### APPEAL SUMMARY

| <b>Appeal ID:</b> 20531                                      | <b>Project Address:</b> 2312 SE Ladd Ave   |

**Code Section** ORSC R311.7.2 Headroom

Hauke|Ely Stair Remodel

6 Stair Section  
1/2" = 1'-0"

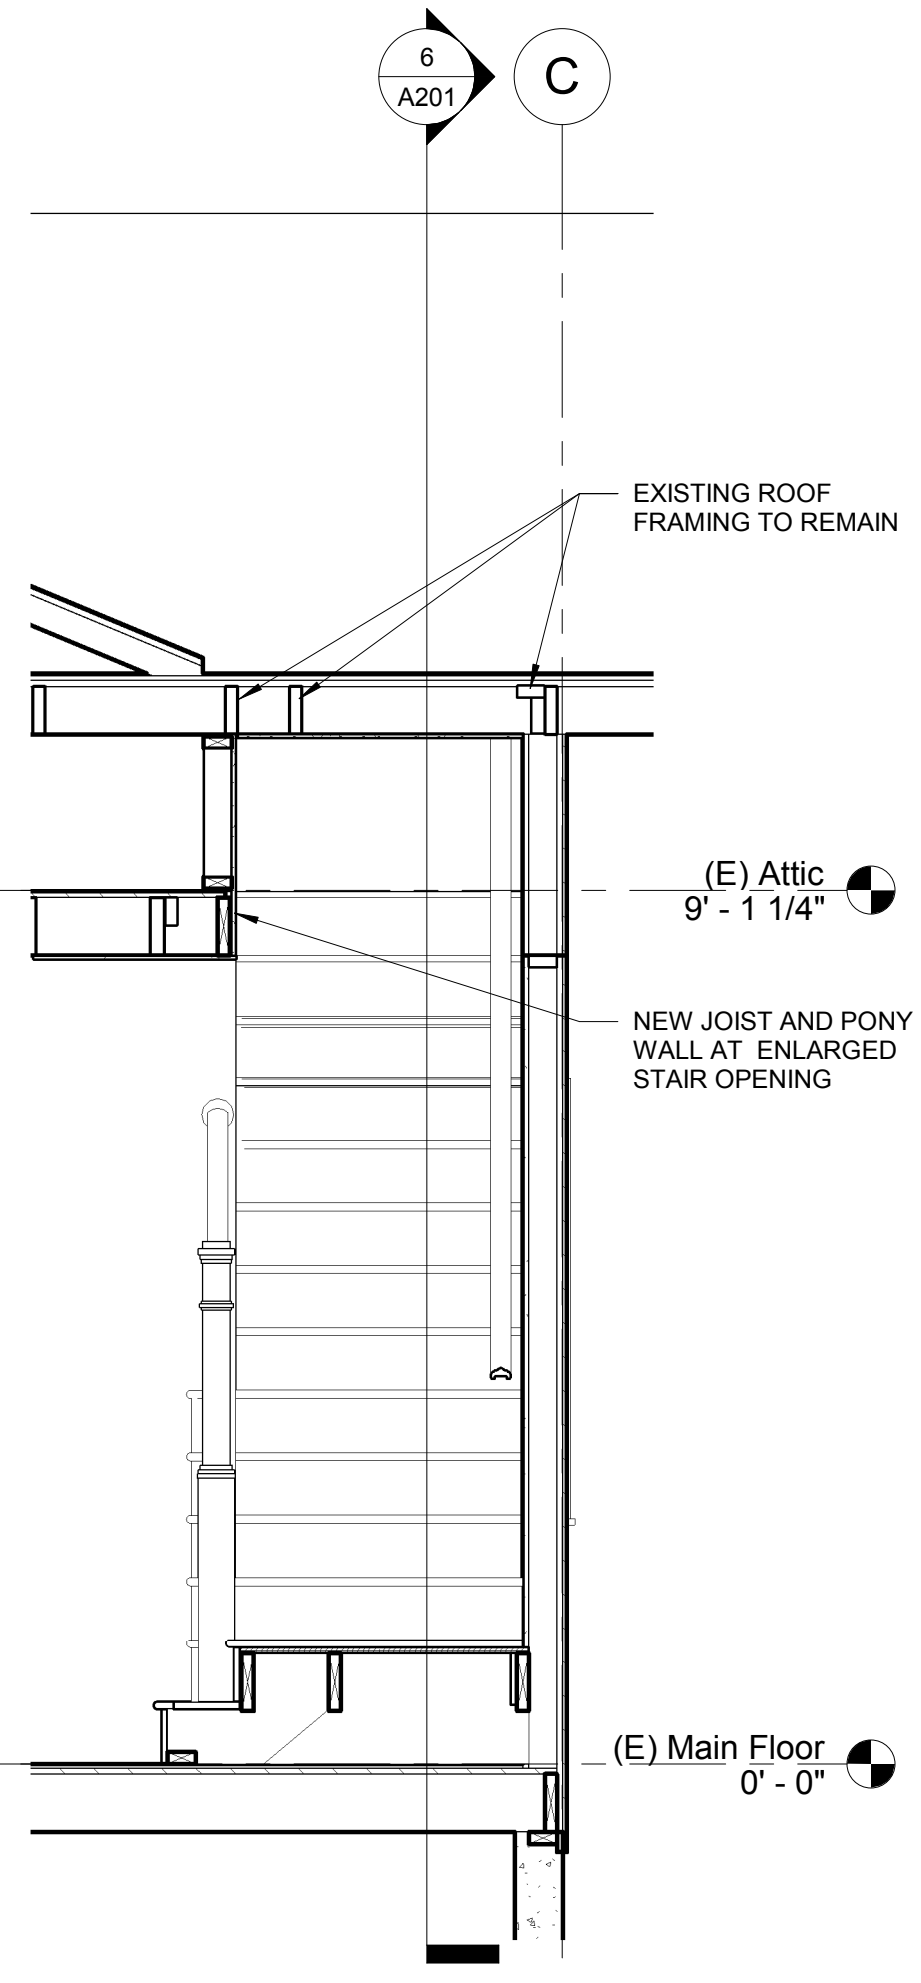
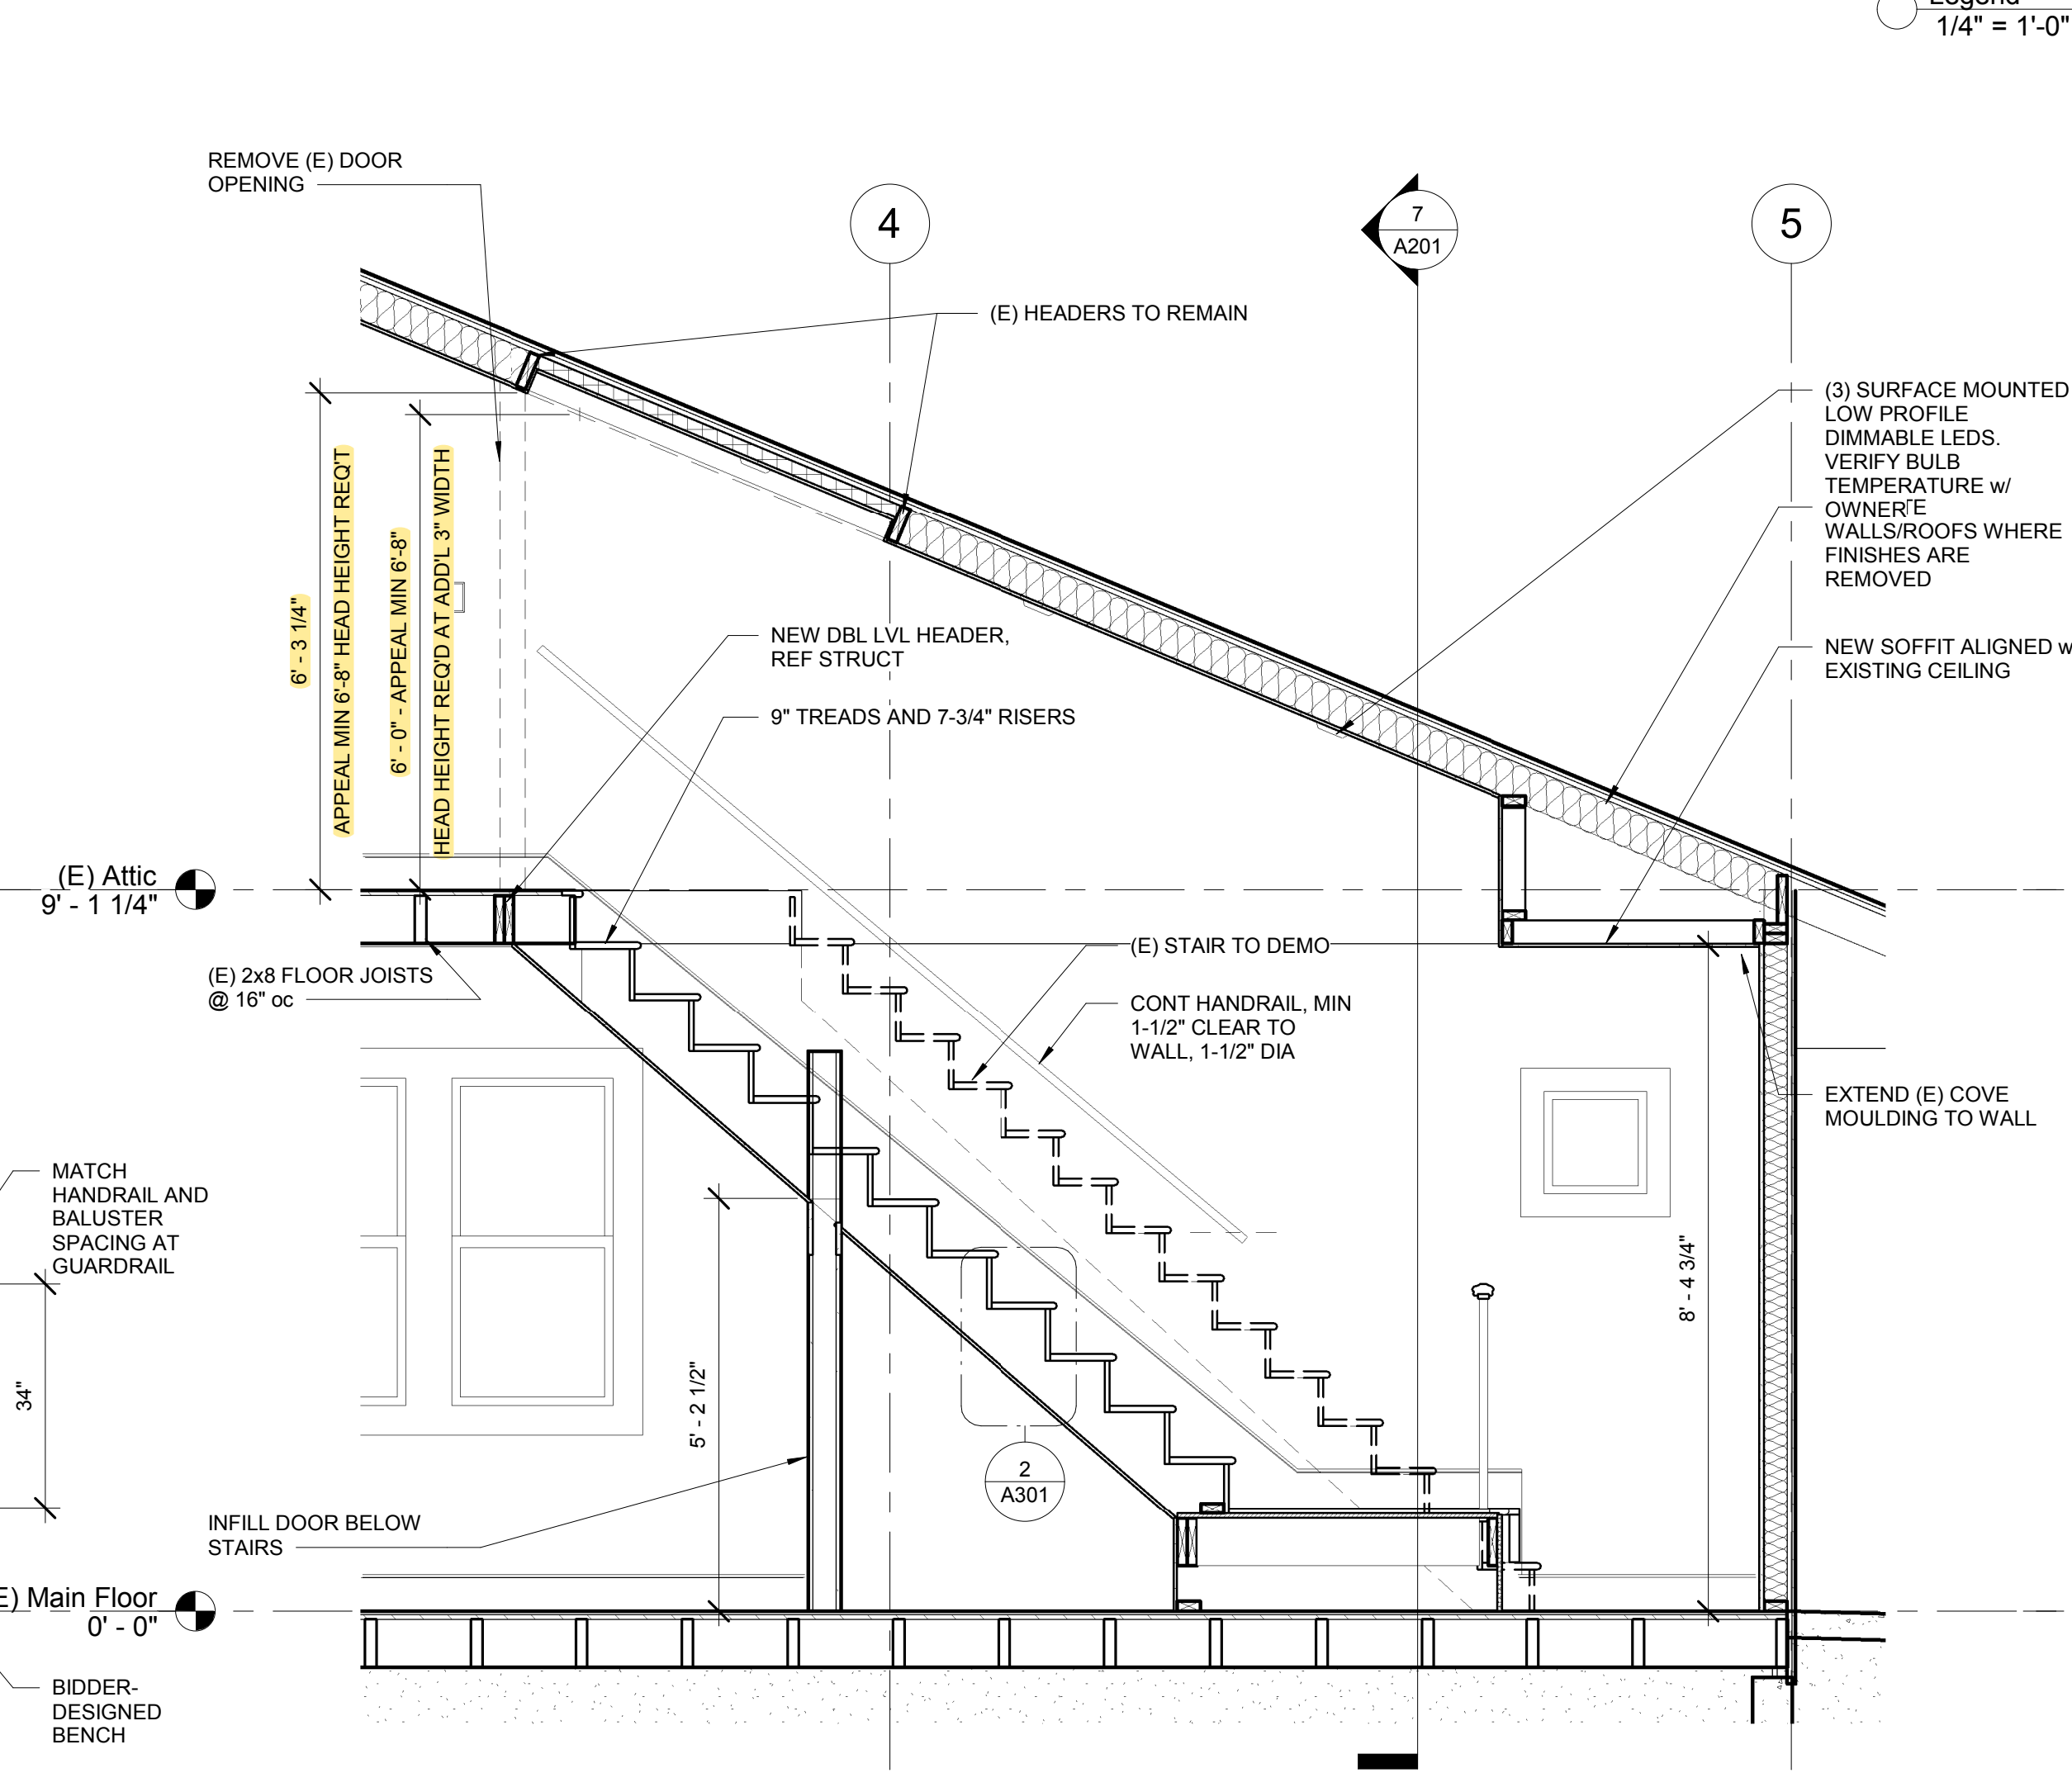
Existing head clearance at top of stairs is 5'-2". A minimum head clearance of 6'-2" will be achieved for the existing 33" width of the stairs. The new 36" wide stairs will only have 6' head clearance for the additional 3" of stair width due to existing roof framing. This is a substantial improvement upon the existing stair configuration to an existing habitable space.

The required 6'-8" minimum is not achievable due to the existing structural framing, avoiding excessive structural modifications and complications with the house being a Contributing Property to Ladd's Addition Historic District. It is not possible to alter the existing roofline.

### **Reconstruction of stairway to 2nd floor with reduction of minimum required headroom to minimum 6'-0" for a 3" width: Granted as proposed.**
